SUBJECT: Response to Request for Additional Information dated February 26, 2014, for Relief Request Number RR 4-18 – Proposed Alternative, Use of Alternate ASME Code Case N-770-1 Baseline Examination

Palisades Nuclear Plant
Docket 50-255
License No. DPR-20

Response to Request for Additional Information for Relief Request Number RR 4-18 – Proposed Alternative, Use of Alternate ASME Code Case N-770-1 Baseline Examination

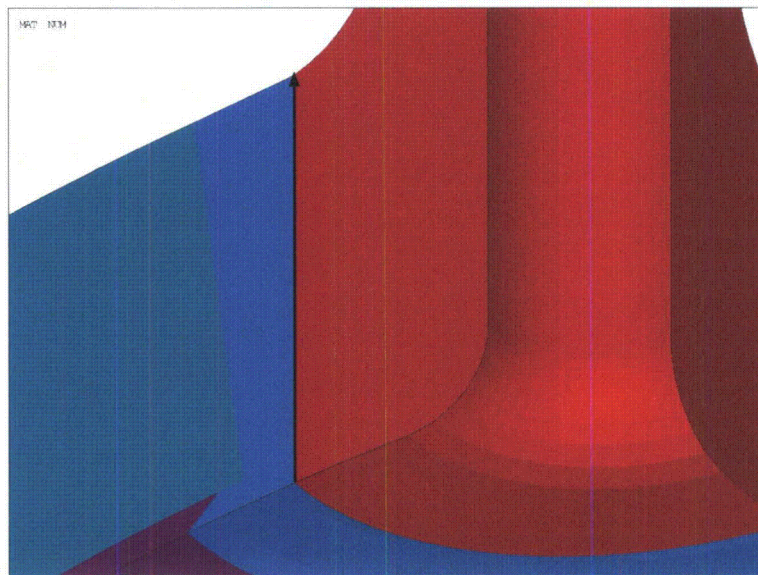
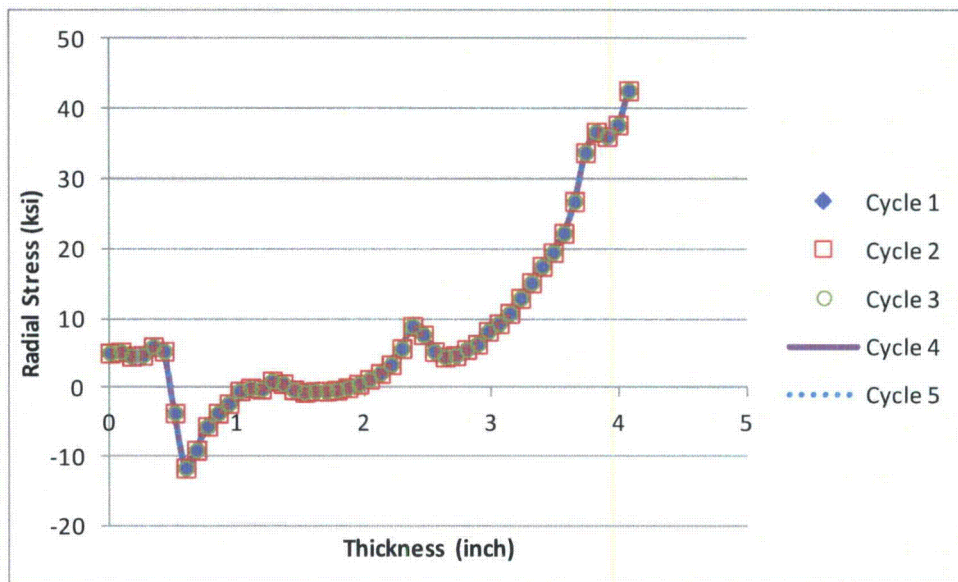
What was the basis for the 5-cycle shakedown – typically it is not included in weld residual stress calculations?

- Why was 5 cycles used versus two or three cycles for example?*
- How was each shakedown modeled?*
- What is the effect of the shakedowns as they were applied? (i.e. provide weld residual stresses for each application of the technique.)*

Operational cycles are frequently included in welding residual stress calculations as a part of determining the operating stress condition. In particular, the standard modeling practice adopted by the xLPR (Extremely Low Probability of Rupture) welding residual stress team, which includes the NRC, national laboratory, and industry participants, specifies that the welded configuration should be cycled between operating conditions and residual conditions to shake down the nonlinear material hardening behavior. Typically, three to five cycles are used to shake down the material's behavior.

- Since the primary interest from the residual stress analysis is to provide residual stresses for calculating stress corrosion crack growth under normal operating conditions, it is desirable to determine a stabilized residual stress state that will not change under normal operating cycles. The as-welded residual stresses usually contain localized peak stresses

at some nodal locations. Applying a few operating cycles will stabilize the stress peaks and valleys due to the slight stress redistribution at elevated temperatures. It has been determined through experience that the residual stresses will stabilize after three to five cycles. Five cycles was used for conservatism.

- b. The modeling of the operating cycles involved simultaneously ramping the operating temperature and pressure between the no load and full load conditions repeatedly five times. Residual stresses at the fifth operating cycle were extracted for the crack growth calculation.
- c. An example through-wall stress path at the weld/nozzle interface at the 90-degree azimuth is used to investigate the residual stresses at each operating cycle. The results show that the residual stresses are stabilized because there is virtually no change in the profiles among the five cycles. This is primarily due to the resulting stresses developed in the fabrication process.

The details of the nozzle are shown on Palisades Drawing M-1D-0108. The hot leg drain nozzle is shown as part number 675-03 as shown below.

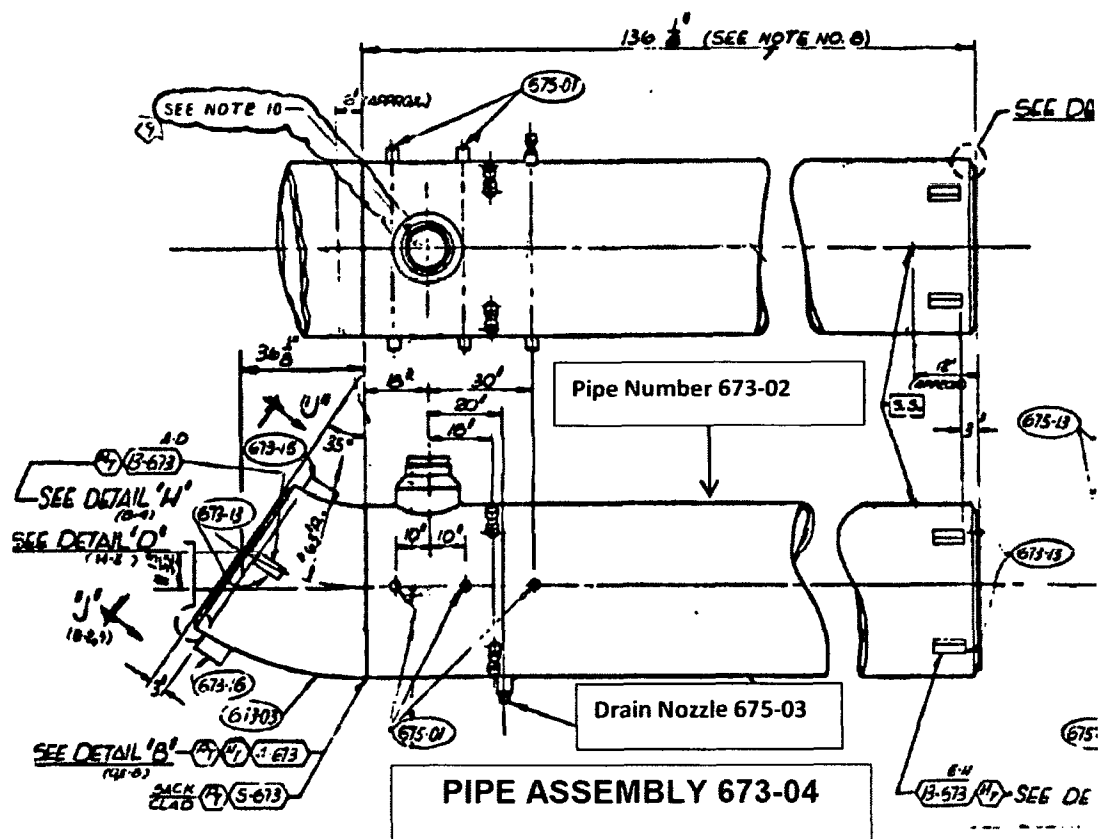
Provide detailed geometry information of the weld, including weld thickness.

The weld is ½ inch wide at the ID of the hot leg pipe and then increases in width at a $7- \frac{1}{2}^{\circ}$ ($+2^{\circ}/-0^{\circ}$) angle to the OD of the hot leg pipe. The thickness of the hot leg pipe is 3-¾ inches.

Weld 5-675 width of 3.75 inches was obtained from the hot leg drain nozzle (675-03) installation drawing. The hot leg drain nozzle is located in pipe assembly 673-04 and is attached to pipe number 673-02 as detailed on Palisades drawing M0001D-0106 and shown below.

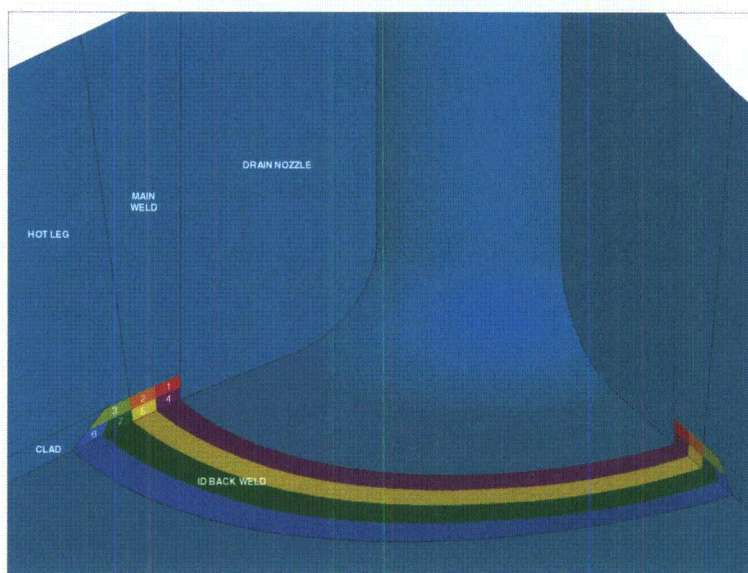
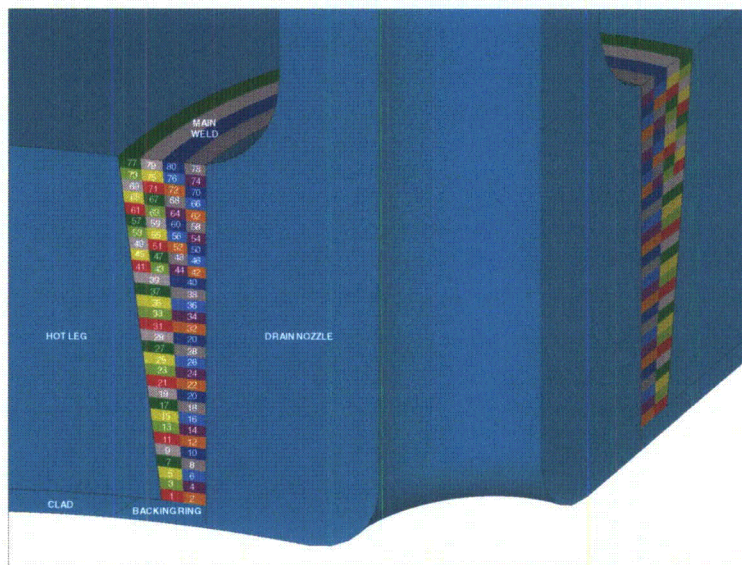
Provide weld bead application sequence.

The weld beads were modeled as full bead rings, with 80 bead rings defined for the main weld, and seven bead rings defined for the inside diameter patch weld per the labeled sequence shown in the figures below.

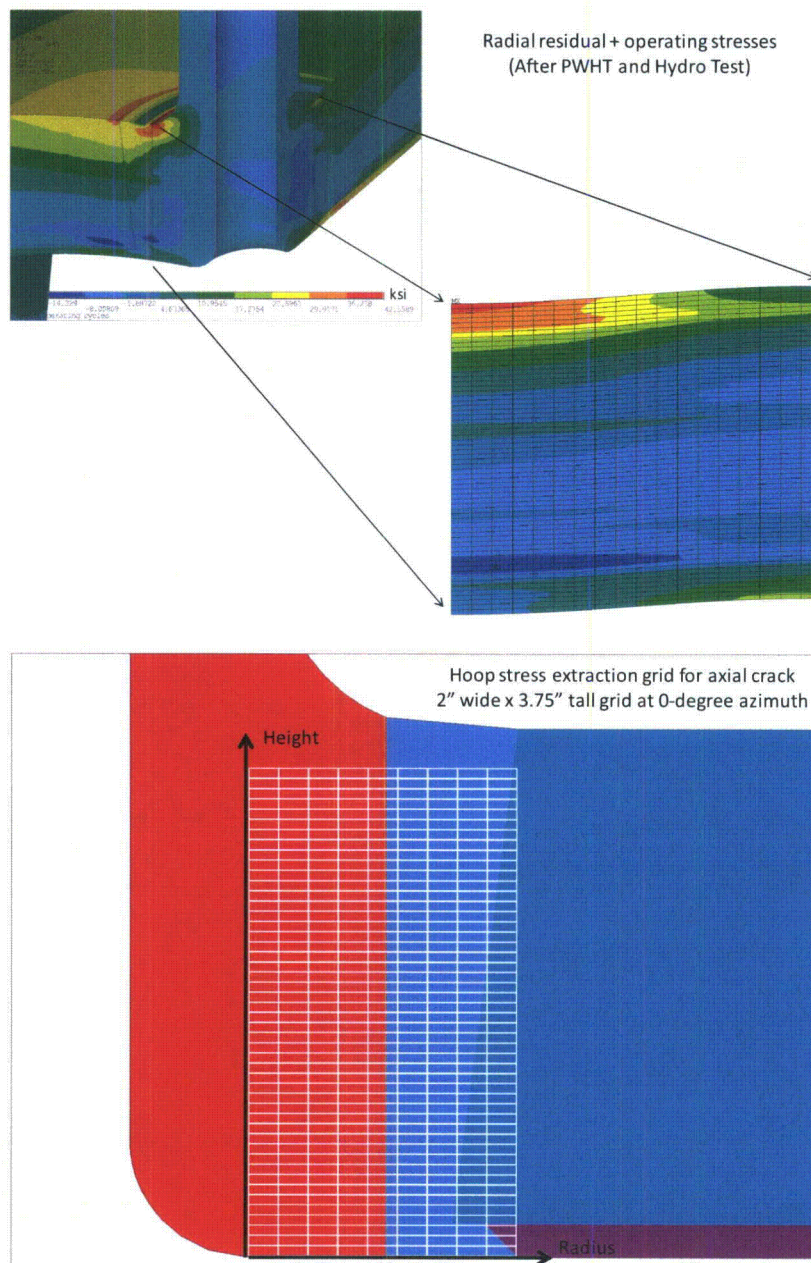
Provide extraction path of WRS profile.

The stress extraction path for the circumferential crack was the radial stresses on the entire weld/nozzle interface area. The stress extraction path for the axial crack was the hoop stresses within a rectangular 2 inch x 3.75 inch grid located on the axial cut plane of the hot leg (i.e., at the 0-degree azimuth).

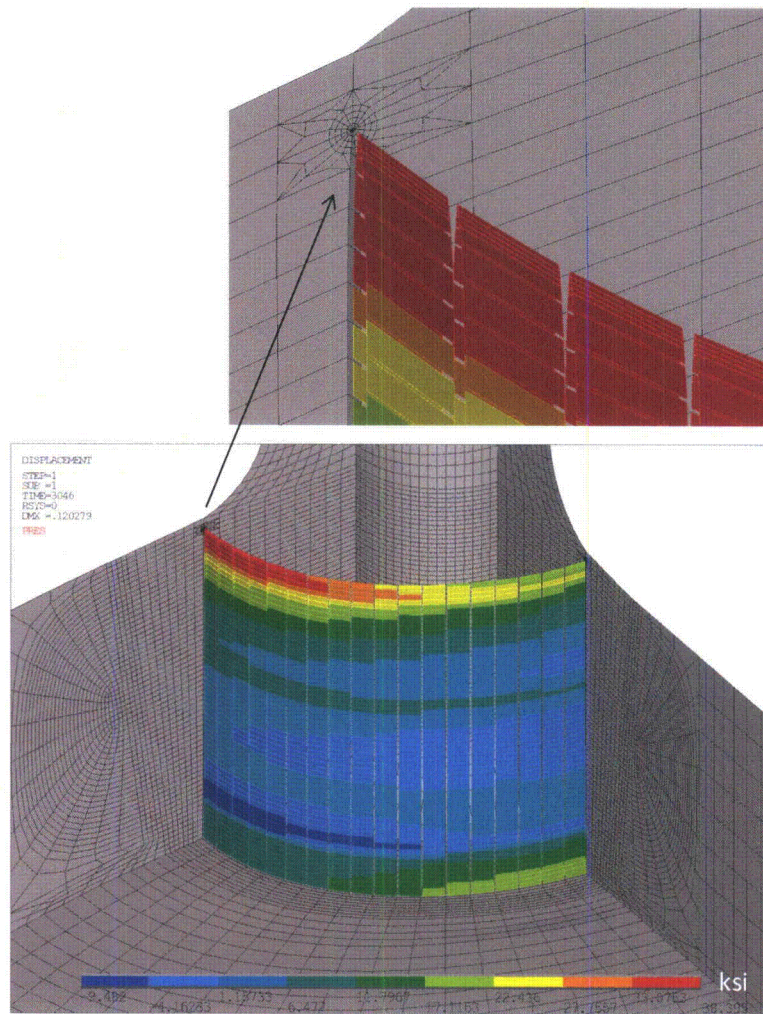
Was the WRS profile fit with a polynomial? If so, what order was the polynomial? If not, how were K values derived?

For the circumferential crack, the stress intensity factors, including the residual stresses, were calculated via deterministic finite element analyses using linear elastic fracture mechanics (LEFM) principles. Seven fracture mechanics finite element models are derived to include “collapsed” crack meshing that represent full circumferential flaws surrounding the nozzle at various depths within the boss weld. The depths vary from 0.13 inch to 3.95 inch.

High order SOLID95 elements in ANSYS were used around the crack tips, with the mid-side nodes shifted to the “quarter point” locations to properly capture the singularities at the crack tips. The 3.95 inches deep crack is shown as an example.

In order to determine the “Ks,” the radial component (relative to the nozzle) residual stresses, plus operating stresses at the boss weld/nozzle interface, were extracted from the residual stress analysis and reapplied on the crack face as surface pressure loading. The transferred radial stresses onto the crack face are also shown in the figure below.
